Special Use Permit #2021-00095
220 East Monroe Avenue
Redevelopment of a Substandard Lot

| Application | General Data | |
|---|-------------------------------------|-----------------------------|
| Request: Public Hearing and consideration of a request for a Special Use Permit with lot modifications for the redevelopment of a substandard lot with a single-family dwelling | Planning Commission Hearing: | January 4, 2022 |
| Address: 220 E. Monroe Avenue | Zone: | R-2-5/Single-and two-family |
| Applicant: Capitol Hill Iron Gate JV, LLC, represented by Timothy Sullivan, agent | Small Area Plan: | Potomac West |

Figure 2 - Proposed Survey Plat

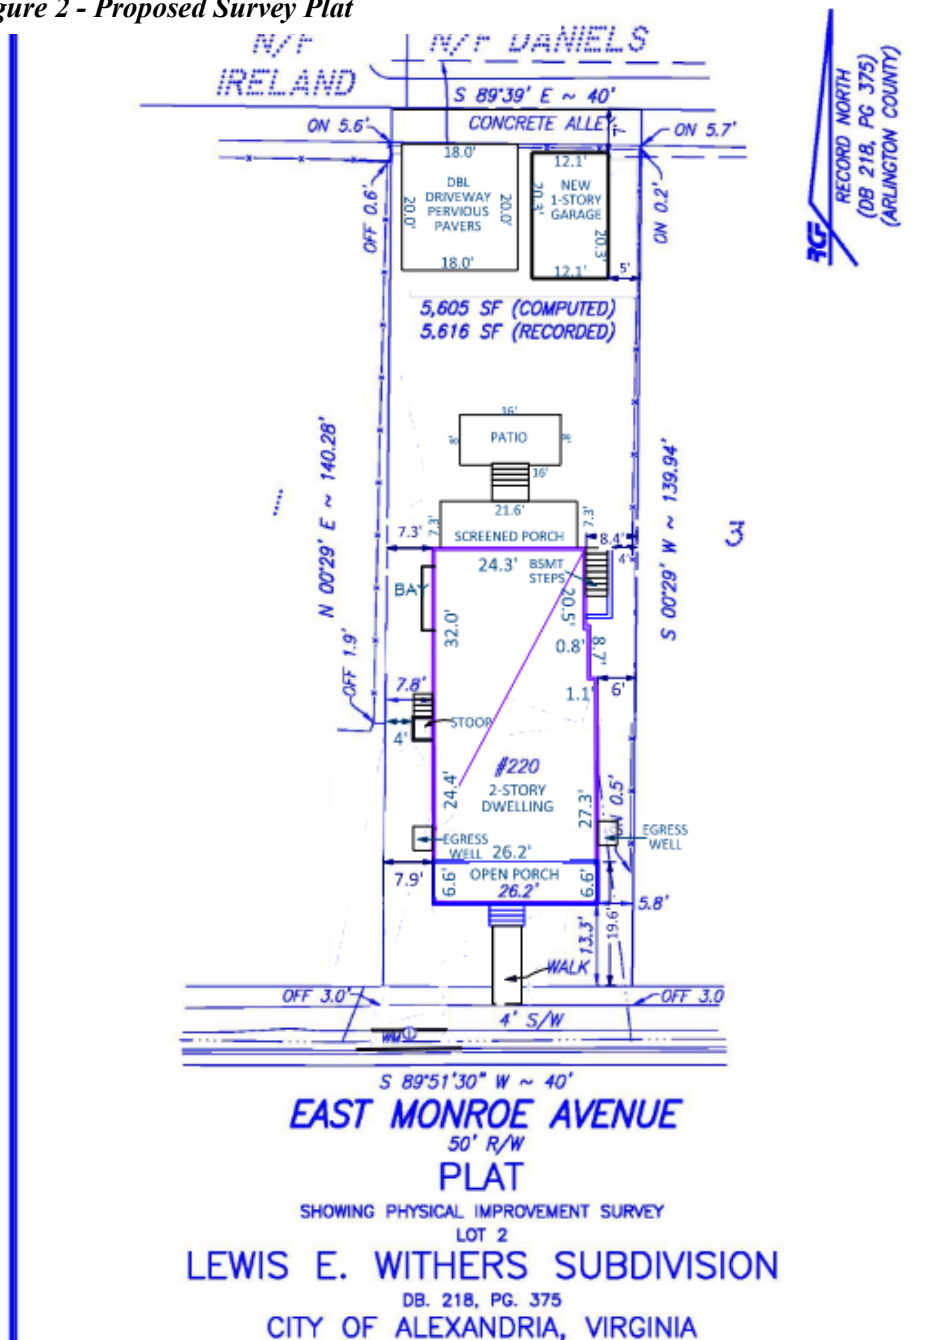
The applicant would demolish the existing home on the property down to the foundation and construct a new two-story single-family dwelling. The applicant seeks a larger home for his family who would like to remain residents of the City of Alexandria. The existing house, while a representative example of Del Ray architectural style and charm, is relatively small. The applicant requests SUP approval with a one-foot east side yard modification to construct a two-story dwelling. The proposed dwelling would have 2,382 square feet of net floor area and would measure 25.3 feet in height from average preconstruction grade to the midpoint of the dwelling's gable roof (Figure 2).

Figure 3 - Proposed Elevations

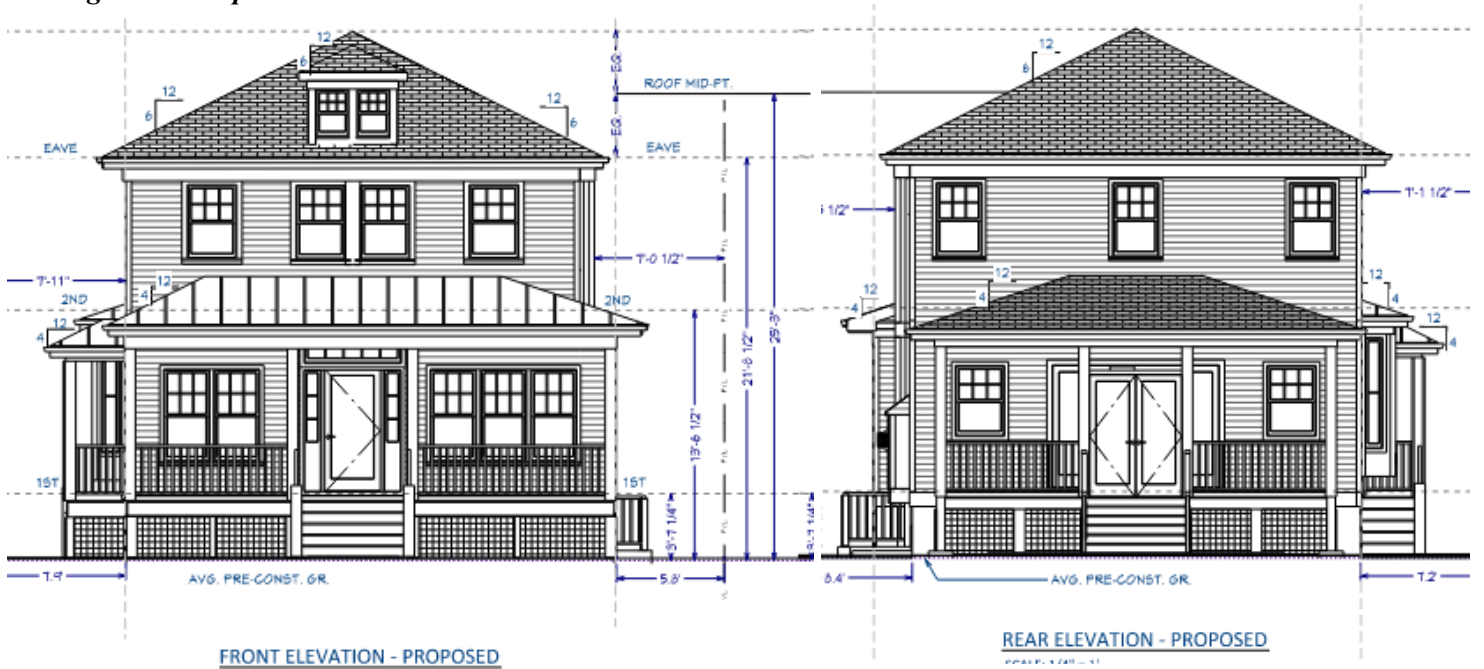
The applicant's proposed design would exhibit a mix of styles. The design would include mostly Foursquare-inspired elements including a traditional rectangular form with a characteristic hipped roof and front gable. The applicant included craftsman details like a front door with side lights and transom and a full-length front porch. The applicant also proposes to close the curb cut on East

Monroe Avenue, remove the existing driveway and accommodate vehicles in a garage and parking pad which would be accessed off the rear alley. Figure 3, below, shows the proposed elevations.

Figure 4 – Comparison of heights

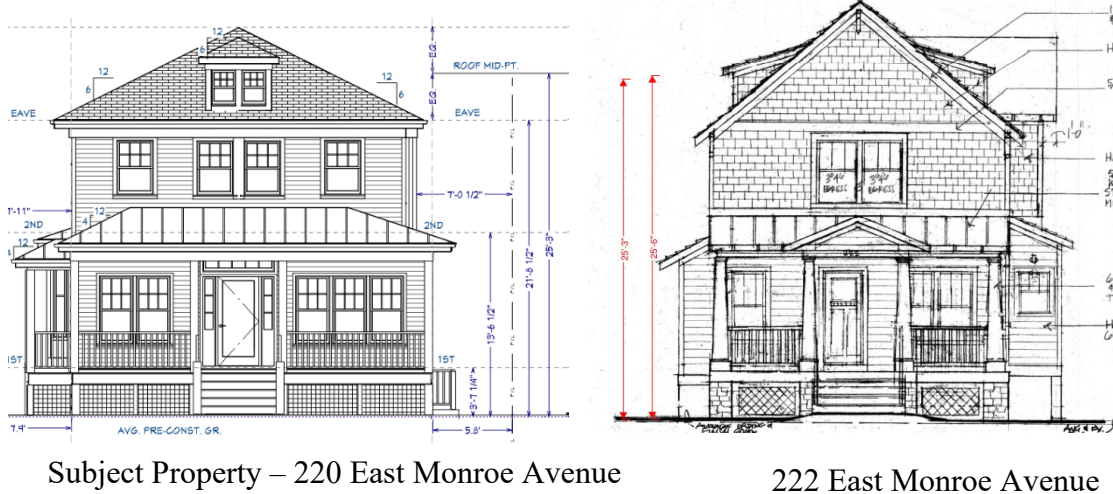
Staff found the proposed height to be compatible with neighborhood character in terms of height. In this case, the comparison dwellings include 222 and 224 E. Monroe Avenue since the structure immediately to the west is a church. The height of the dwellings along this side of the block are most relevant to assess a height comparison are shown in Table two, below.

Upon discussion with staff, the applicant decreased the main structure's roof pitch from the original submittal, reducing the overall height and bulk of the attic space. Staff finds that the height of the proposed dwelling would be nearly identical with the neighboring dwellings at 222 E. Monroe Avenue and 224 East Monroe Avenue, See Figure 4 for a comparison between the subject property and 222 E. Monroe Avenue, which City Council recently approved as a substandard lot SUP. The proposed dwelling is slightly shorter than 222 and 224 E. Monroe Avenue neighbors and would be similar in the perceived height to the two-story townhouse dwellings across the street, all of which are approximately 25 feet tall. At 25.3 feet, the proposed dwelling would also be 4.7 feet below the maximum height permitted by the R-2-5 zone of 30 feet, if the proposal qualified as by-right construction on a standard-sized lot.

Further, the applicant is proposing to increase the front yard setback from 13.3 feet to 19.6 feet (not including the front porch) to better align with neighboring properties. This increased distance from the front property line, will also minimize the perception of height and bulk from the street.
